February 21, 2024

**RE: Potter Valley Hydroelectric Project, FERC No. 77-CA
2024 Minimum Instream Flow Variance Request Due to Restricted Storage
Capacity**

Figure 2: Average Daily Water Temperature at Gaging Station E-2 with 2022 trend line.

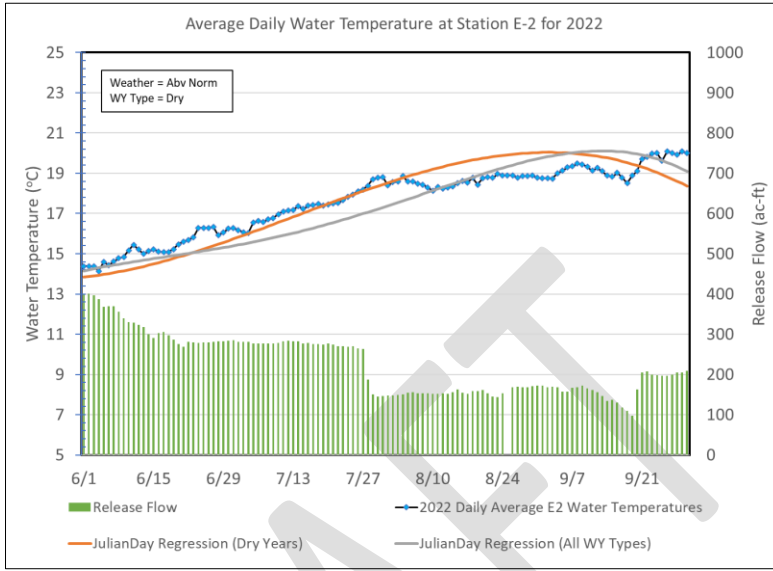
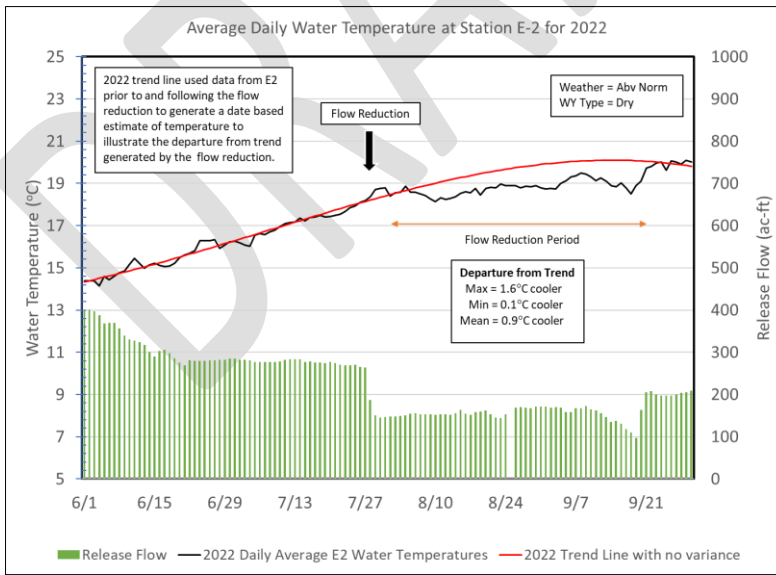
- Commented [SM24]:** May want to describe what a guidance curve is here rather than force the reader back into Enclosure 2. I think it is the regression lines in Figure 1 and 2.
- Commented [JAF25R24]:** Agreed
- Commented [PJ26R24]:** PG&E concurs, language added
- Commented [JAF27]:** Nice!

Figure 2: Average Daily Water Temperature at Gaging Station E-2 with 2022 trend line.

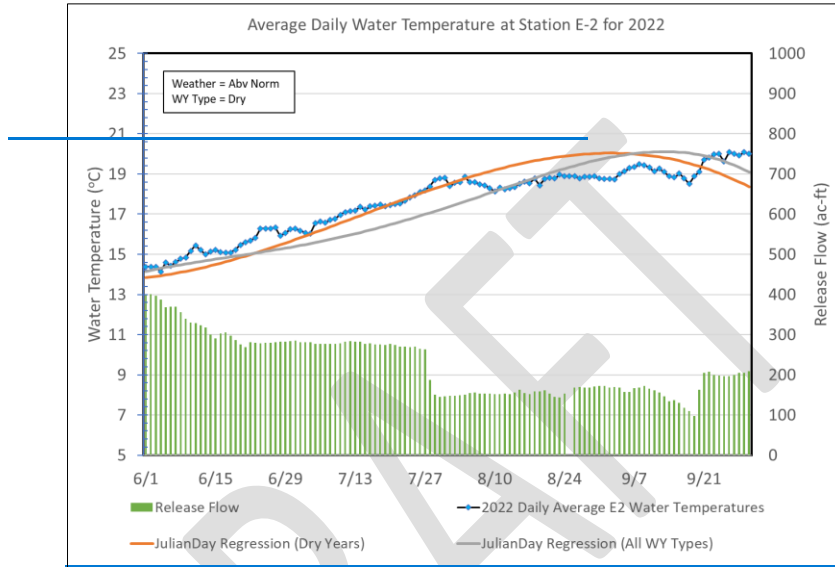
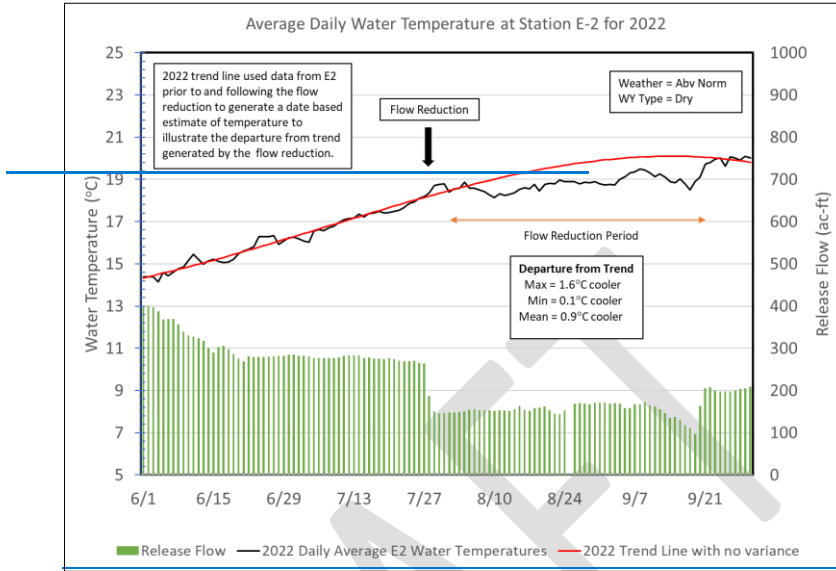
Commented [SM81]: May want to describe what a guidance curve is here rather than force the reader back into Enclosure 2. I think it is the regression lines in Figure 1 and 2.

Commented [AA83R81]: Text added

Figure 3: Average Daily Water Temperature at Gaging Station E-2 and Release Flow for 2023

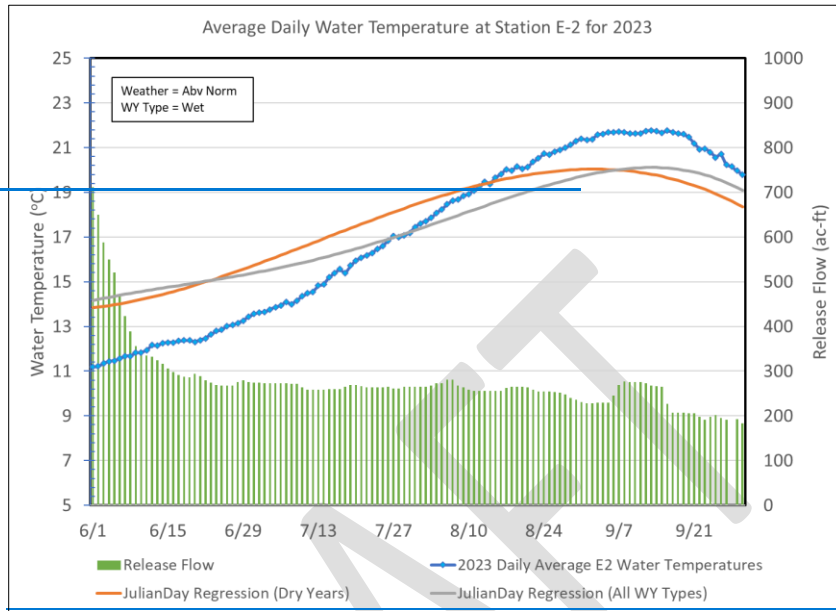
- Commented [SM85]: Should be defined way earlier
- Commented [PJ86R85]: Moved to page 2
- Commented [JAF87]: Resource Entities? Tribes okay with being lumped into "Agencies"? I defer to RVIT.
- Commented [PJ88R87]: See comment above

Figure 4. Comparison of Average Daily Water Temperatures at Station E-2.

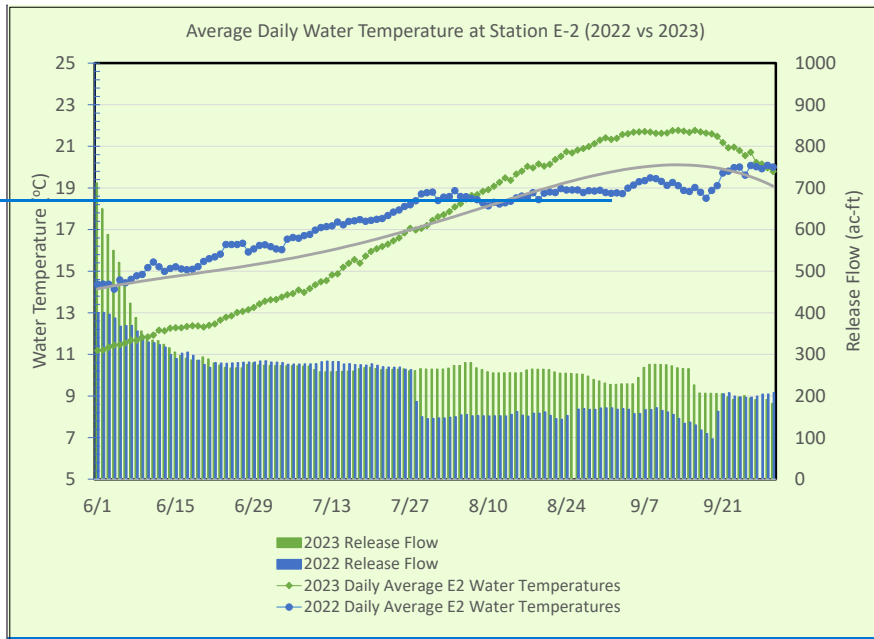
Commented [JAF89]: True not true? June 1 start or May 1?

Commented [PJ90R89]: See comment above
